MEETING MINUTES FROM THE
MARICOPA ASSOCIATION OF GOVERNMENTS
STANDARD SPECIFICATIONS AND DETAILS COMMITTEE

2009 PROPOSED REVISIONS TO MAG SPECIFICATIONS AND DETAILS

Case # 08-10

RE: **Modifications Detail 200, Section 336 & Section 601: Trench Backfill and Pavement Replacement**

TYPE "A" LONGITUDINAL TRENCH
(trench in pavement parallel to traffic)

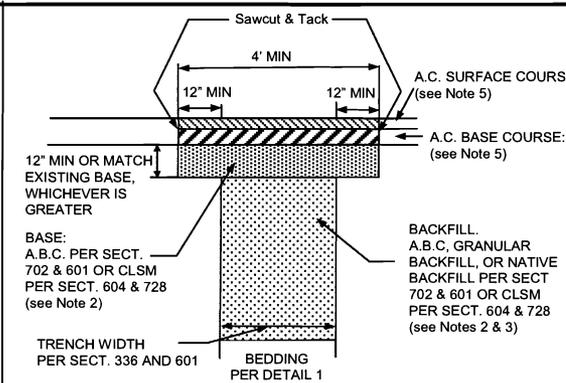
- Recommended for longitudinal cuts
- Allows option of CLSM along with ABC for base
- AC section to be specified by special provisions or plans
- AC base and surface courses separately identified
- Includes new requirement for removal of 24" remnant between cut and curb
- References trench width to Sections 336 & 601

TYPE "B" TRANSVERSE TRENCH
(trench in pavement not parallel to traffic)

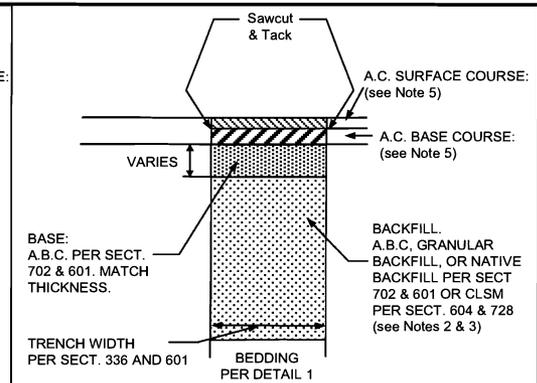
- Recommended for transverse cuts
- Base shown separately. Allows option of CLSM along with ABC
- 1" minimum AC surface course deleted. AC section to be specified by special provisions or plans
- AC base and surface courses separately identified
- AC section to be specified by special provisions or plans
- Allows backfill options of select & native along with CLSM & ABC
- References trench width to Sections 336 & 601

TYPE "B-MODIFIED"

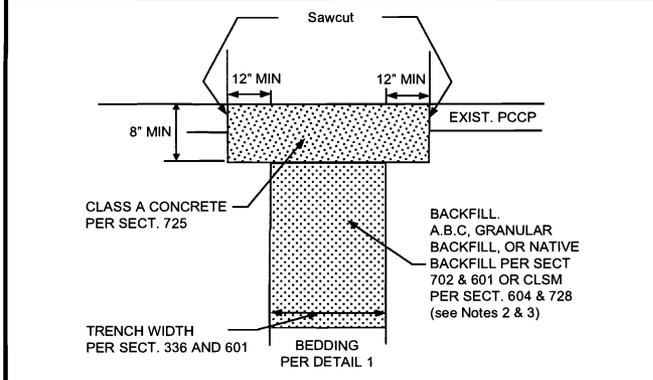
- Includes separate base – to match existing
- Allows backfill option of ABC, select & native along with CLSM
- References trench width to Sections 336 & 601
- 2" minimum AC thickness deleted. AC section to be specified by special provisions or plans
- AC base and surface courses separately identified

TYPE "C"
(trench in portland cement concrete pavement)

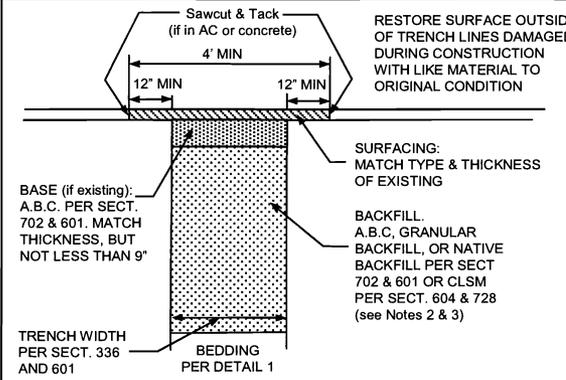
- Edge sawcut included
- References trench width to Sections 336 & 601

TYPE "D"
(trench in right-of-way but not in paved roadway)

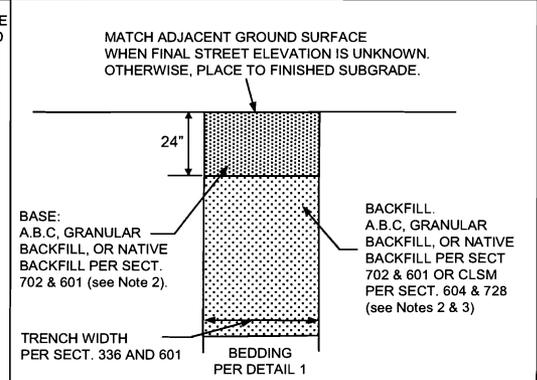
- Combined into new Type D
- Recommended for trenches in ROW but not in paved roadway
- ABC base shown separately – to match existing if present instead of 9" per Note 4
- Defines backfill options to allow ABC, select, native or CLSM
- Surfacing to be specified by special provisions or plans – no minimums shown
- References trench width to Sections 336 & 601

TYPE "E"
(trench in future roadway prism or alley)

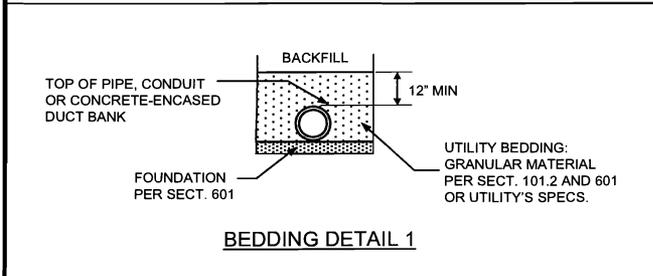
- Recommended for use in future roadway prism or alley
- Same as Type A, but with no pavement section

PAVEMENT REPLACEMENT FOR TRENCHES (T-TOP)

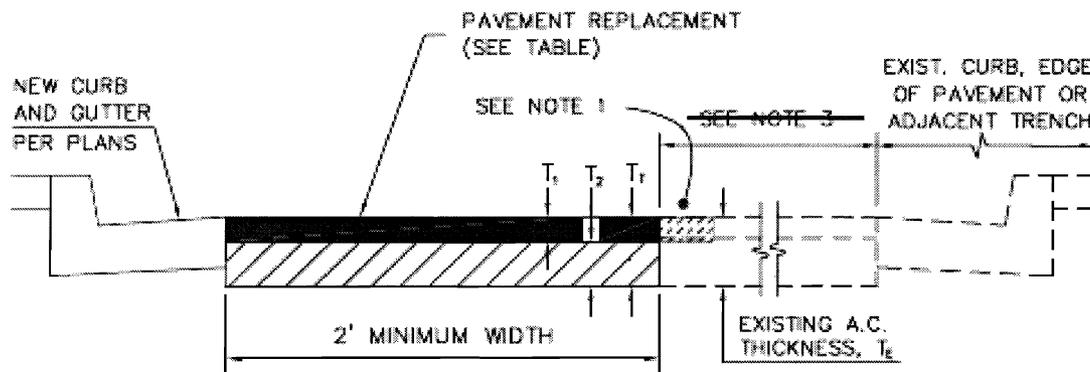
- a. FOR PAVEMENTS 4 YEARS AND OLDER: INITIAL A.C. REMOVAL TO BE THE MINIMUM WIDTH REQUIRED FOR PROPER TRENCH COMPACTION. SAWCUT & REMOVE 12" OF A.C. MINIMUM ON EACH SIDE OF THE TRENCH FOR THE "T"-TOP AFTER THE BACKFILL MATERIAL IS PLACED. PAVEMENTS 4" AND THICKER, MILL AND REMOVE THE TOP 2" OF THE SURFACE COURSE A MINIMUM OF 6" ON EACH SIDE OF THE T-TOP PRIOR TO PLACEMENT OF THE FINAL SURFACE COURSE LIFT.

- b. FOR NEW AND OVERLAYED PAVEMENT LESS THAN 4 YEARS OLD AND WHEN ALLOWED UNDER THE PROVISIONS OF SCOTTSDALE REVISED CODE SECTIONS 47-79 AND ALL PAVEMENTS WITH RUBBERIZED SURFACE COURSES: INITIAL A.C. REMOVAL TO BE THE MINIMUM WIDTH REQUIRED FOR PROPER TRENCH COMPACTION. SAWCUT & REMOVE 12" OF A.C. MINIMUM ON EACH SIDE OF THE TRENCH FOR THE "T"-TOP AFTER THE BACKFILL MATERIAL IS PLACED. PAVEMENTS 4" AND THICKER, MILL AND REMOVE THE TOP 2" OF THE SURFACE COURSE EQUALLY ON BOTH SIDES OF THE TRENCH TO A MINIMUM TOTAL WIDTH OF 10 FEET. FOR PAVEMENTS LESS THAN 4" THICK SAWCUT, REMOVE AND REPLACE THE ENTIRE PAVEMENT SURFACE TO A MINIMUM TOTAL WIDTH OF 10 FEET, AS DIRECTED BY THE ENGINEER.

- c. FOR DEEP PAVEMENT STRUCTURES REQUIRING TWO OR MORE PAVEMENT BASE LIFTS: INITIAL A.C. REMOVAL TO BE THE MINIMUM WIDTH REQUIRED FOR PROPER TRENCH COMPACTION. SAWCUT, REMOVE AND REPLACE A.C. ON BOTH SIDES OF THE TRENCH AS NECESSARY TO ACCOMMODATE A RIDE ON TYPE VIBRATORY ROLLER COMPACTOR FOR PLACEMENT OF THE A.C. BASE COURSE LIFTS, MATCH EXISTING A.C. DEPTH. MILL AND REMOVE THE TOP 2" OF THE SURFACE COURSE EQUALLY ON BOTH SIDES OF THE TRENCH TO A MINIMUM TOTAL WIDTH OF 10 FEET.

2. ~~ASPHALT CONCRETE SHALL BE IN ACCORDANCE WITH THE REQUIREMENTS OF MAG SECTION 324.~~
3. ~~IF PAVEMENT REMNANT IS LESS THAN 36", REMOVE AND REPLACE PAVEMENT AS PER THIS DETAIL.~~

2. EXCEPT AS REVISED ABOVE, PAVEMENT MATCHING AND SURFACE REPLACEMENT SHALL BE IN ACCORDANCE WITH MAG 336.
